Check report by Sales + CR after finishing stage IV (Apartments)

GULMOHAR RESIDENCY

Details of Additions & Alterations

Flat No	602	Block no.	' G '
Flat Area	1360 sft	Type	Deluxe / Luxury
Buyer Name	Manoj Kumar Reddy		
Phone No.	9505309222	Email	Reddy.manoj@gmail.com

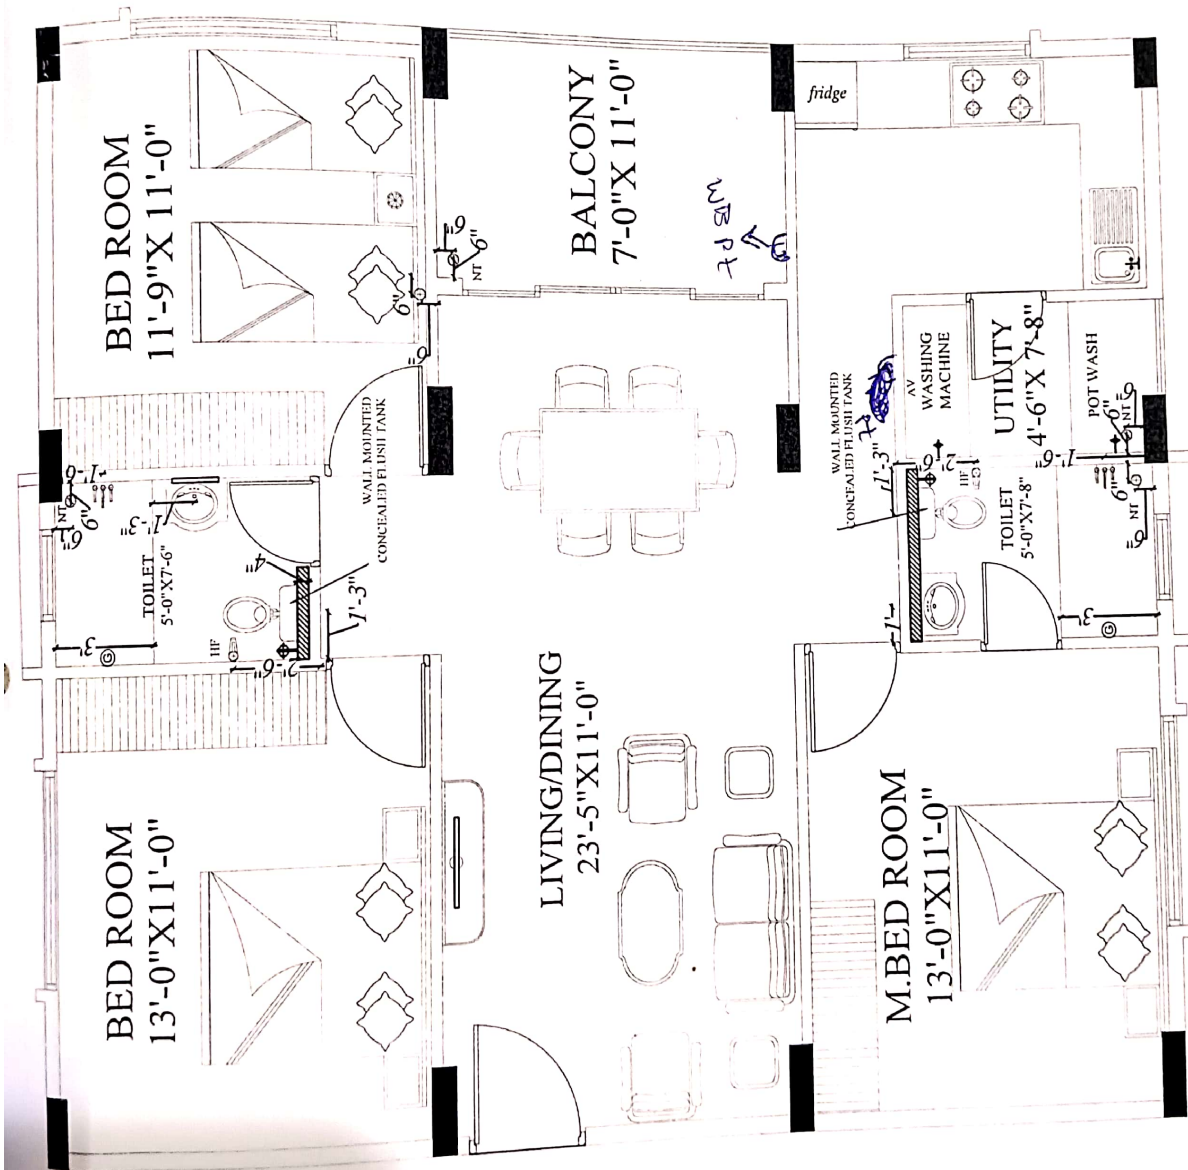
- 1) 6amps electrical pt to be provided in ^{at 3'-0" ht} Master bedroom ^{& Guest children room} marked in plan.
- 2) 16amps electrical pt to be provided in dining marked in plan.
at 4'-0" ht ht.

1) RCC platform to be casted in kitchen

1) utility door to be as per default plan.

2) Wall near kitchen to be dismantled.

Description	Direction	Owners & Developers :		Date :	16.09.20	Promoted by
		Modi Reality Mallapur LLP		Prepared By :	Jayapradha	
		Project Name & Phase :		Approved By :	Soham Modi	
		Gulmohar Residency		Scale :	N.T.S	
PLUMBING PLAN-1360 Sft (A2-TYPE)

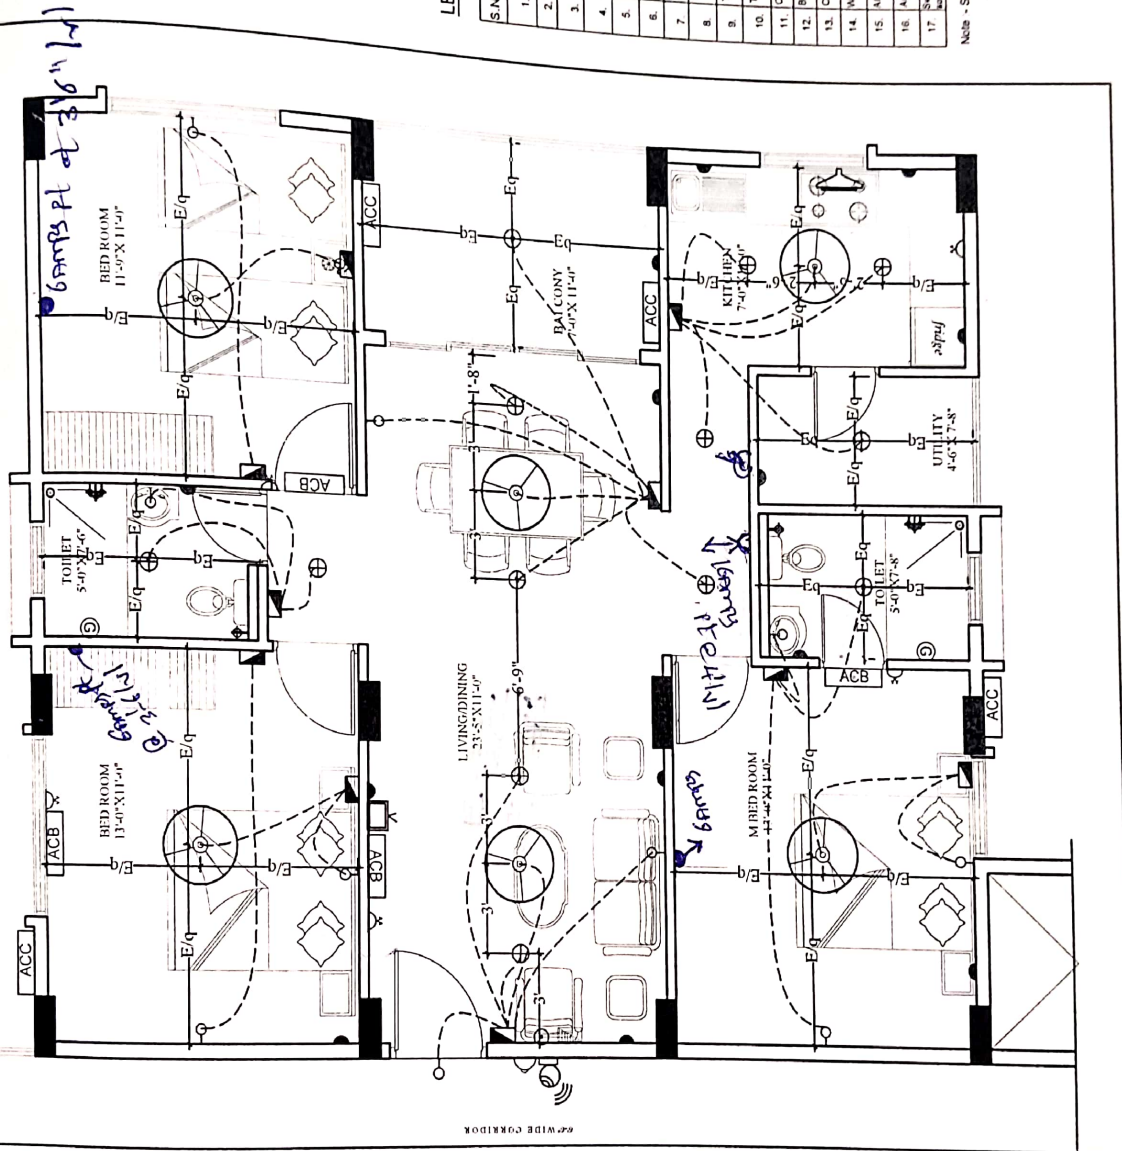
- 1) In master toilet health faucet pt to be shifted from East side to north side wall
- 2) In common toilet health faucet pt to be shifted from west side to South side wall.
- 3) Extra WB pts to be provided in ~~dining near stairs~~ and in balcony Southern wall marked in plan.
